BMC MINERALS (NO.1) LTD.

KUDZ ZE KAYAH PROJECT

RESPONSE #2 TO YESAB EXECUTIVE COMMITTEE ADEQUACY REVIEW OF KZK

November 2017

Figure 8-1: Updated Water Quality Predictions at KZ-37 in the 1/10 Dry Year Scenario Using Preliminary Acidic Drainage Loading Terms for Antimony, Arsenic, Cadmium, Copper, Lead, Selenium, Uranium, and Zinc

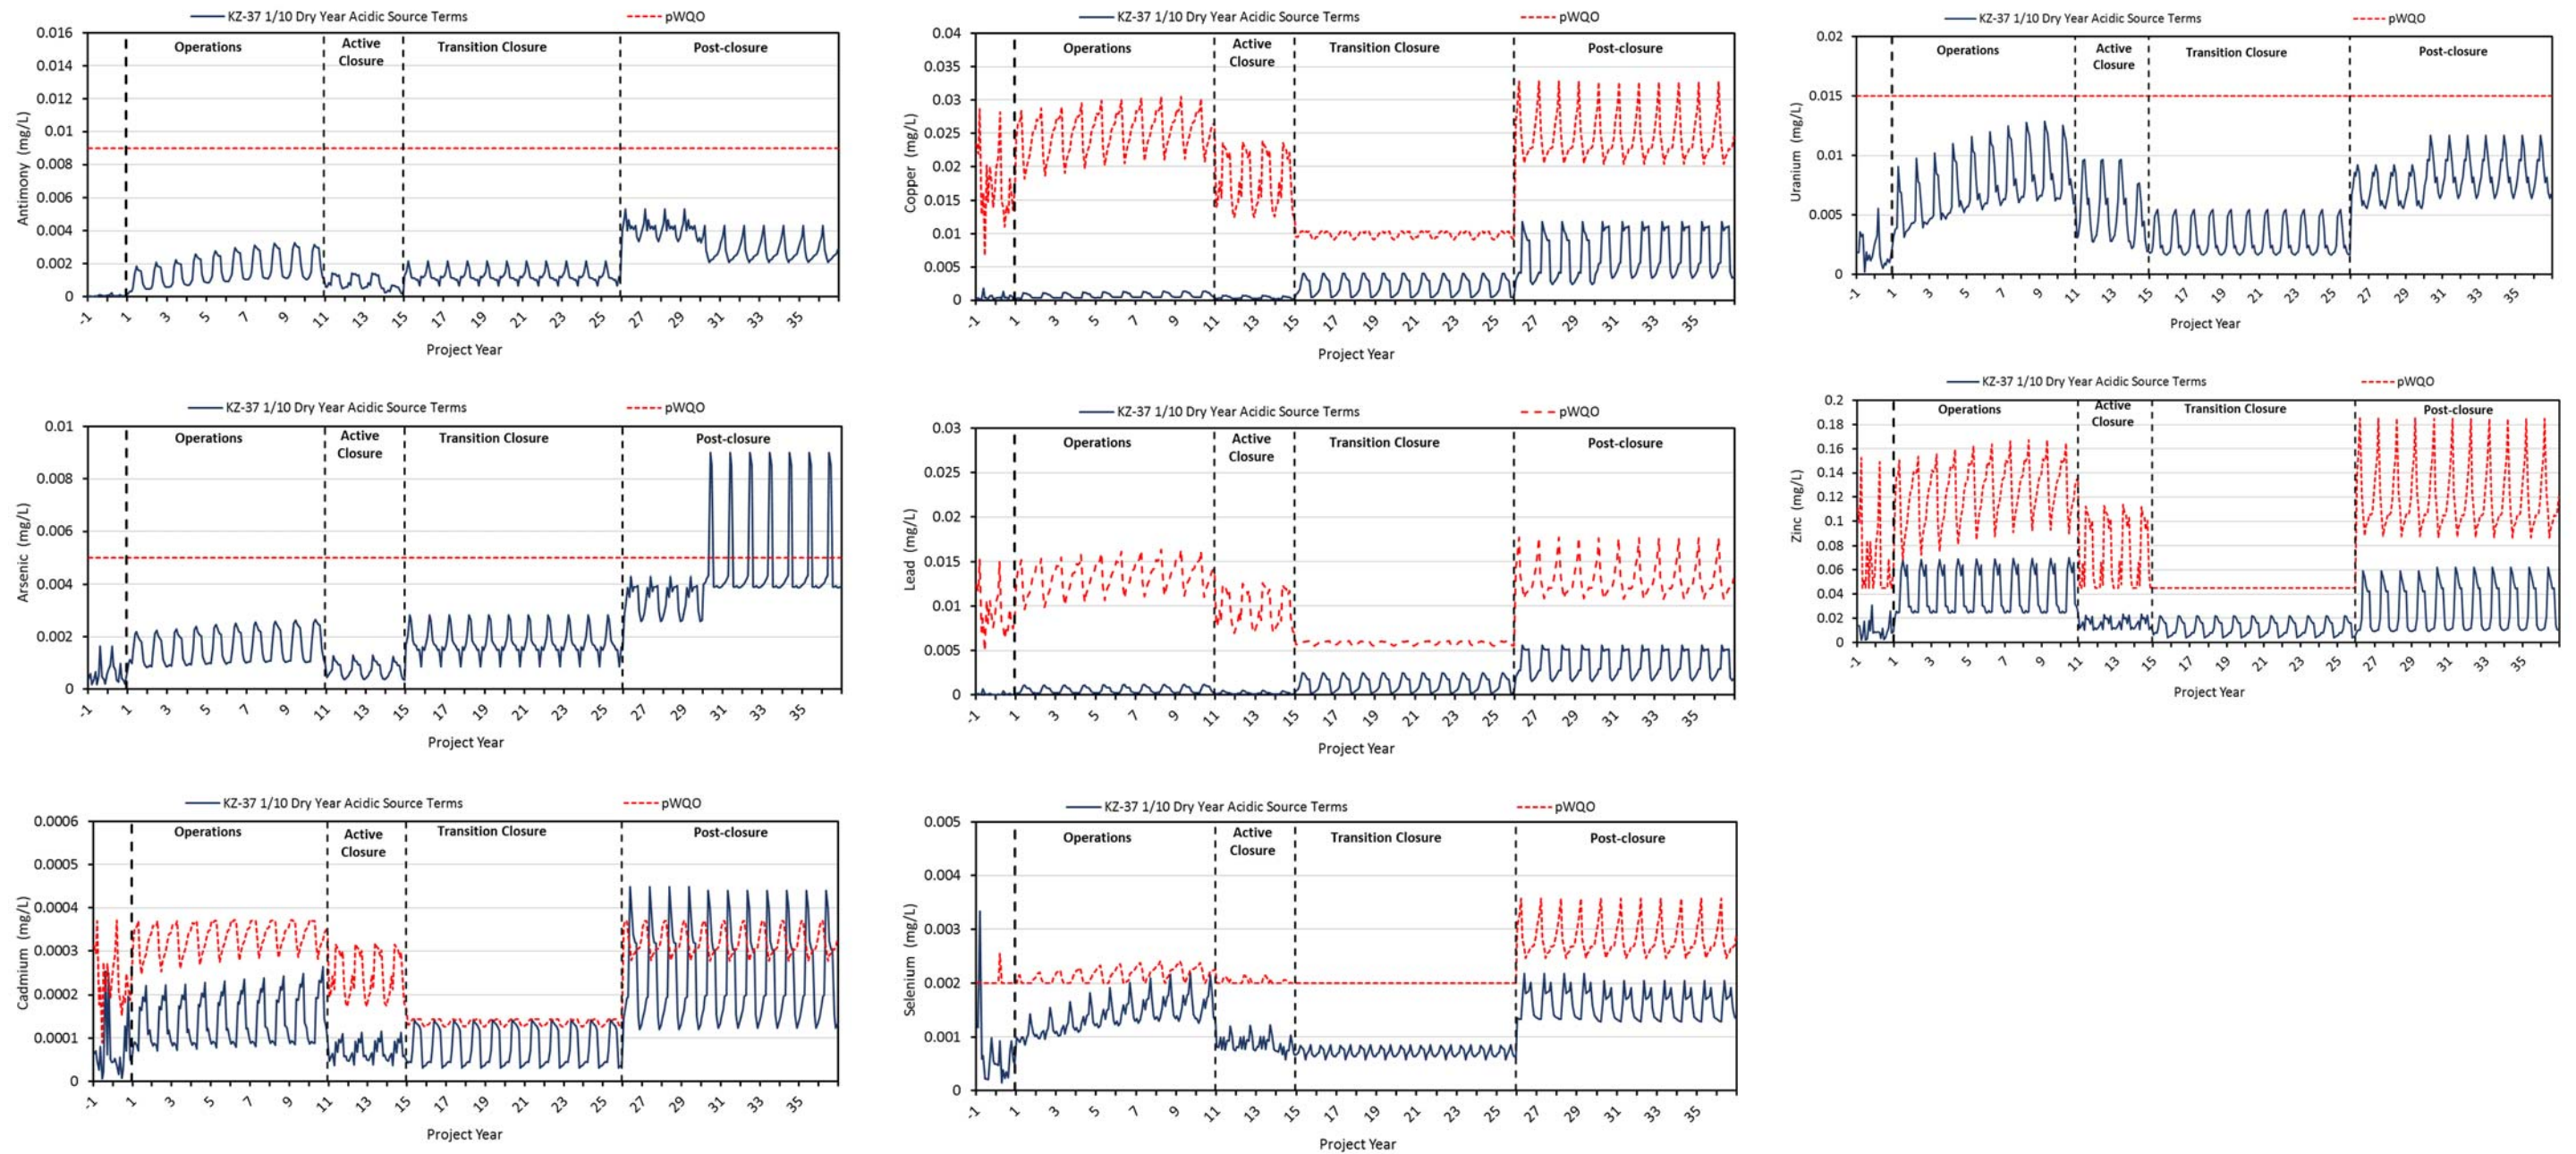
Table 8-1 above were applied in the water quality model at Year 10 for Class A and Year 30 for Class B under both the mean and 1/10 dry year precipitation scenarios. The resulting estimates of COPI water quality for the near field site KZ-37 under the most conservative 1/10 dry year scenario (i.e. the scenario that results in the highest concentrations in the receiving environment) are reproduced below (Figure 8-1). The preliminary water quality objectives (pWQO) are presented for comparison for each COPI [note that some pWQO thresholds are dependent on hardness (cadmium, copper, lead, zinc) or sulphate (selenium) concentrations, giving rise to changing pWQO levels for these COPIs as the hardness and sulphate concentrations vary throughout the year and phase of the Project].

Acidic source terms will be refined upon the availability of NP-depleted kinetic testing data and the models and predictions will be updated accordingly. Appropriate refinements to the mitigation measures may be also be made at that time.

Figure 8-4 Water Balance Flow Schematic

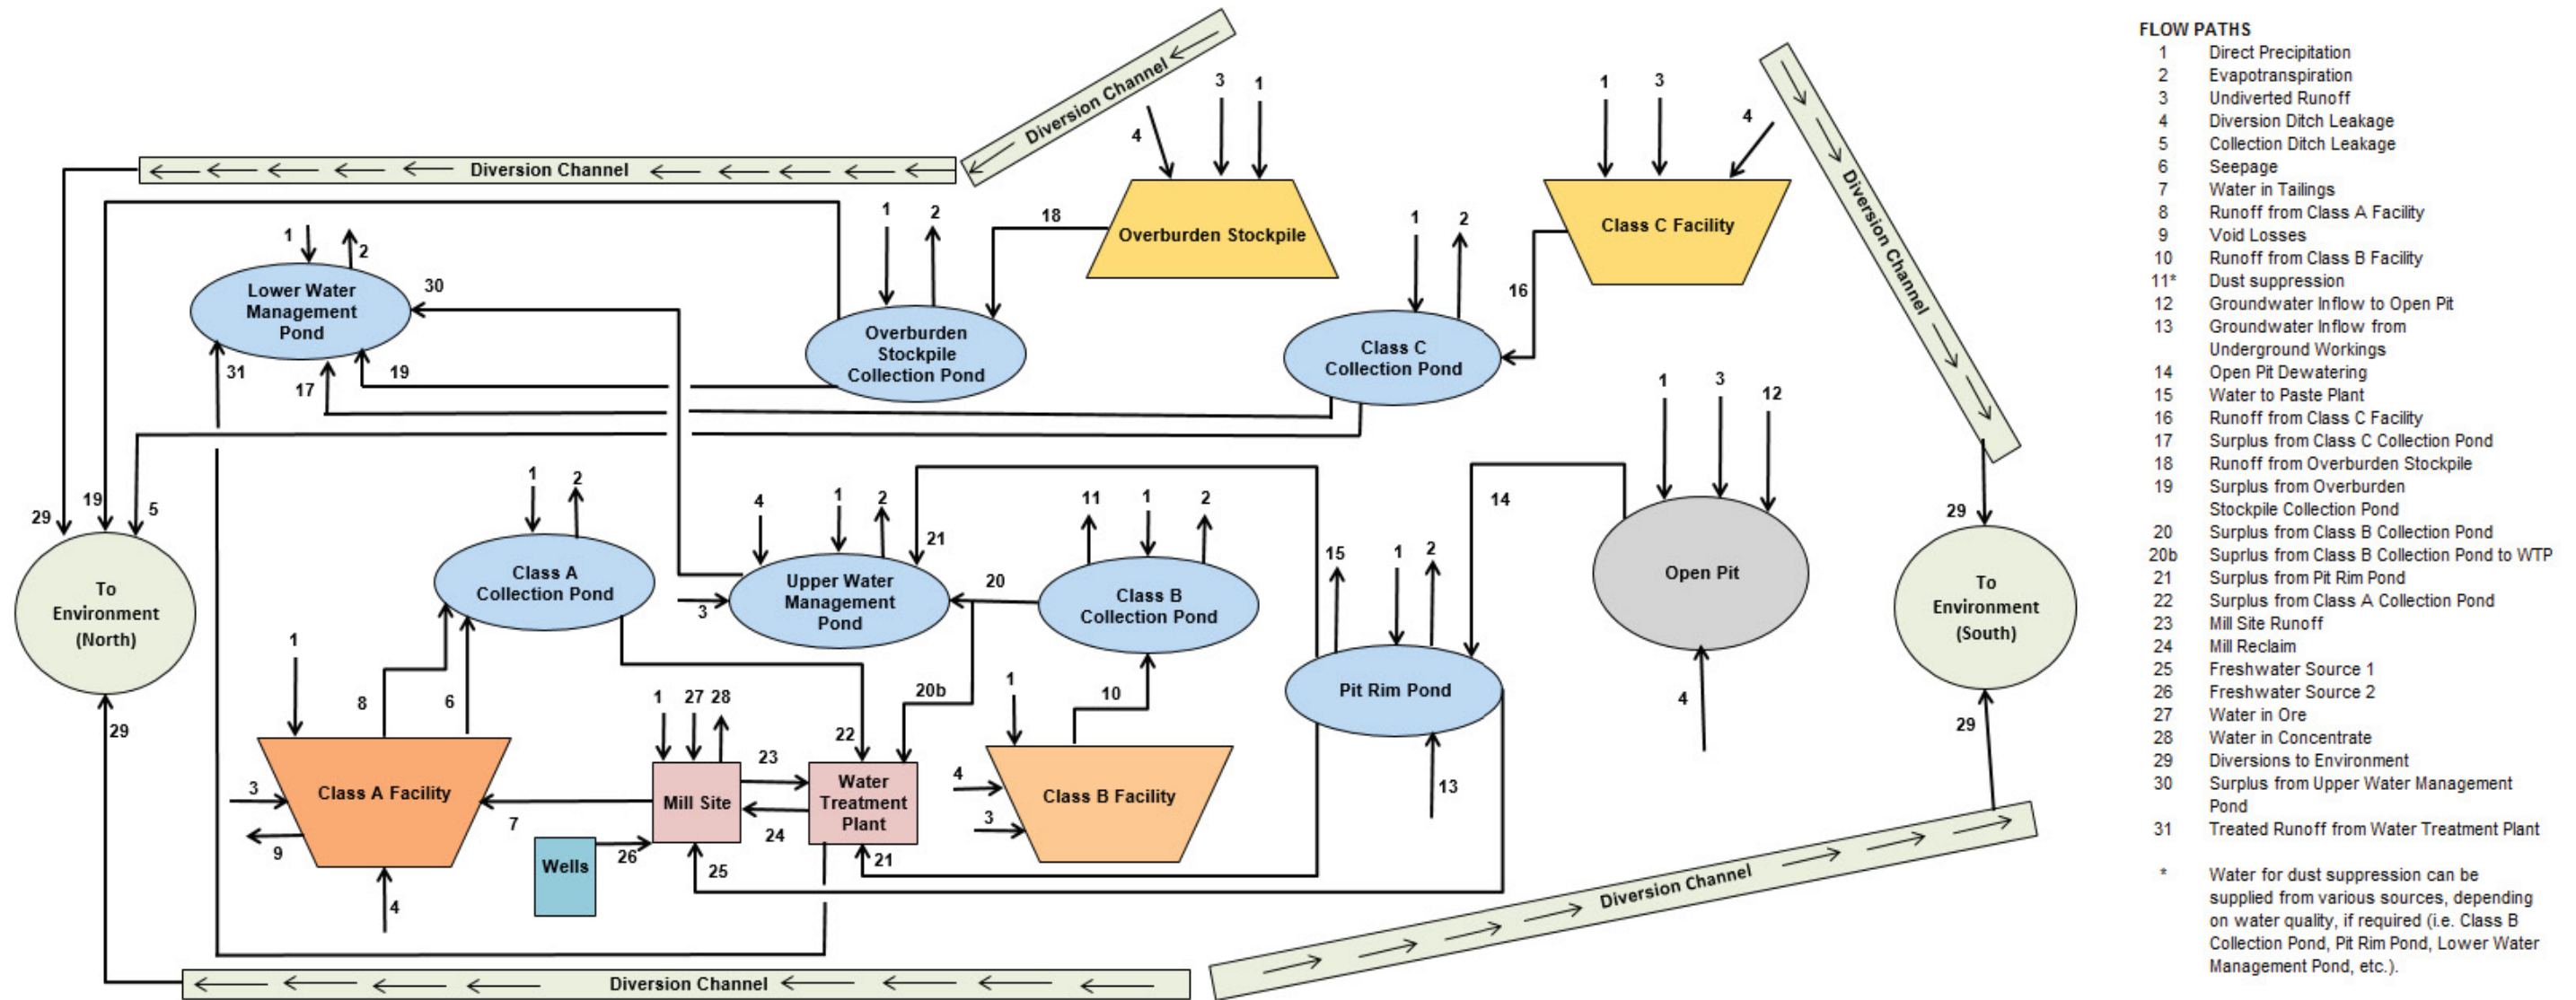
ECCC notes that contact water from the ditches designed to divert flows around the proposed Overburden Stock pile and Class C Storage facilities is proposed to be discharged directly to Geona Creek at the same location as the non-contact water downstream from the lower water management pond (Figure 1.1 Appendix C-7 Water Balance Model Report). The Proponent states:

Appendix C-7, Water Balance Model Report, of the Project Proposal describes the water balance components and Figure 3.1 Water Balance Flow Schematic illustrates the treatment of the components with regard to the water balance model. The schematic is reproduced below as Figure 8-4 to clarify the inputs that have all been included in the model.

Figure 8-5: Predicted percent change in runoff relative to baseline in Geona Creek (KZ-37) throughout Project phases under three precipitation scenarios

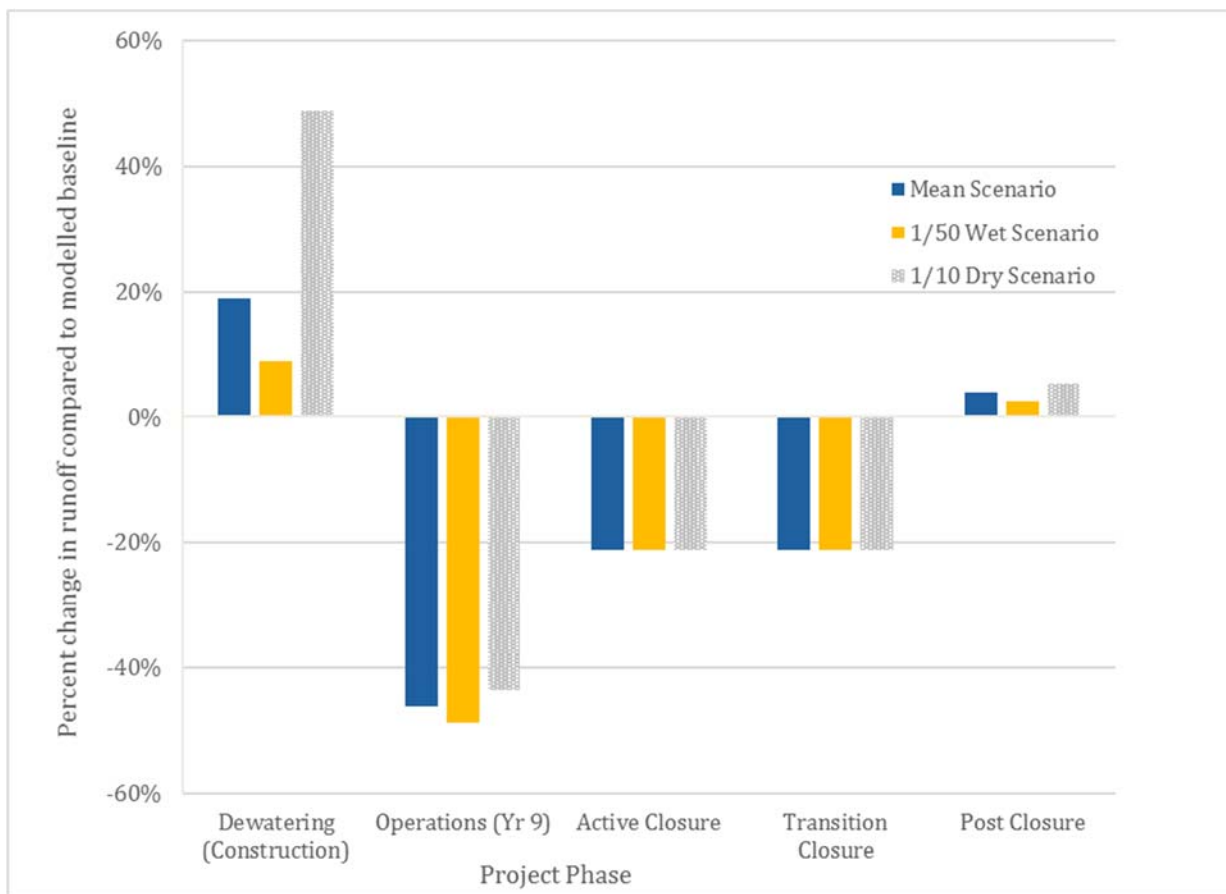
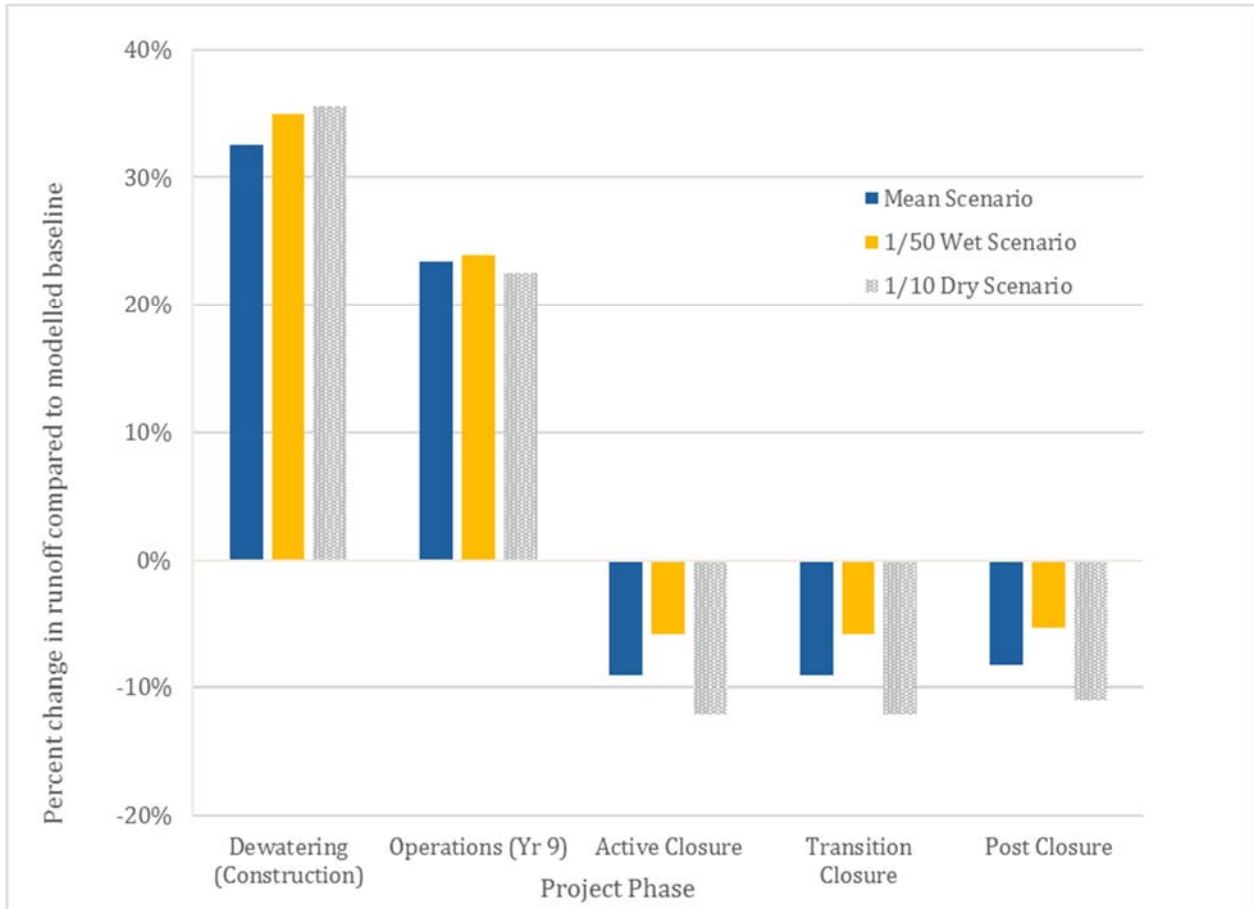
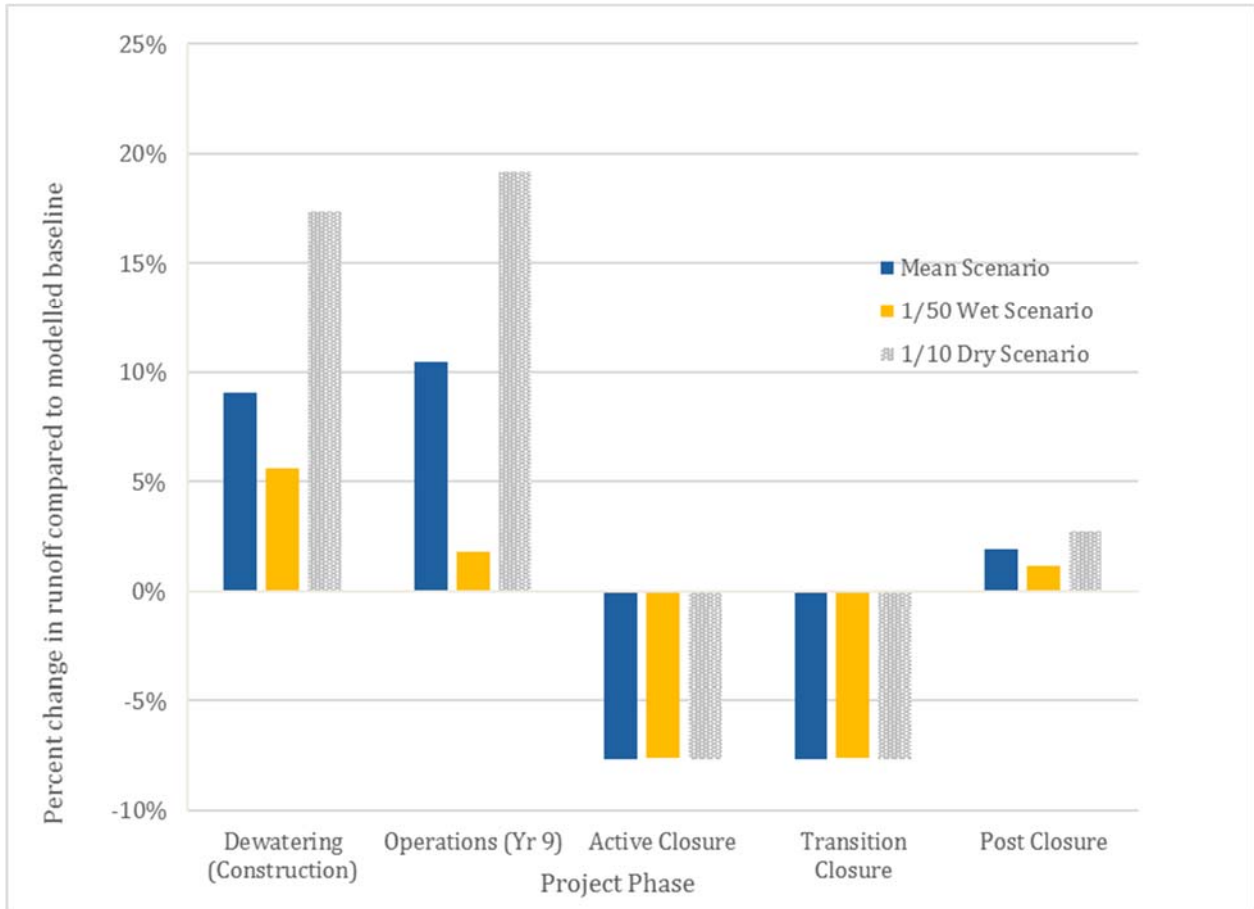
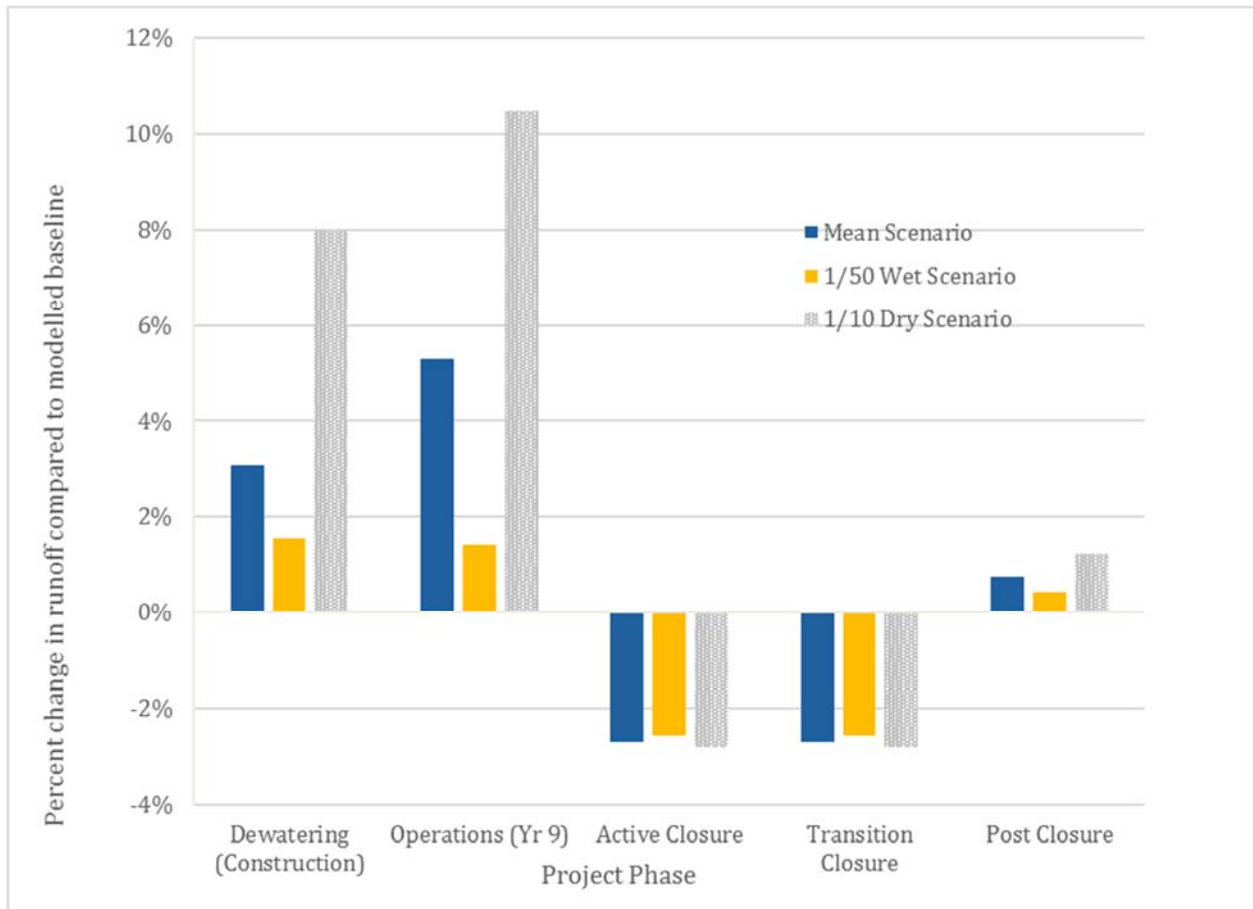
When looking at variability, predicted changes in runoff volumes relative to baseline conditions during the various Project phases and under mean, wet and dry scenarios were presented in the Project Proposal (Figures 10-8 to 10-11) and are reproduced as Figure 8-5 to Figure 8-8 (below) for Geona Creek, Finlayson Creek and South Creek. Table 8-11 below summarizes the values used to generate the figures.

Table 8-11 and the figures below shows that for the scenarios evaluated, the greatest predicted increase in runoff volumes is expected to occur during the dewatering (construction) phase, with the highest predicted increases expected at station KZ-13 (South Creek) for the mean and 1 in 50 wet year scenarios and at KZ-37 (Geona Creek) for the 1 in 10 dry year scenario.
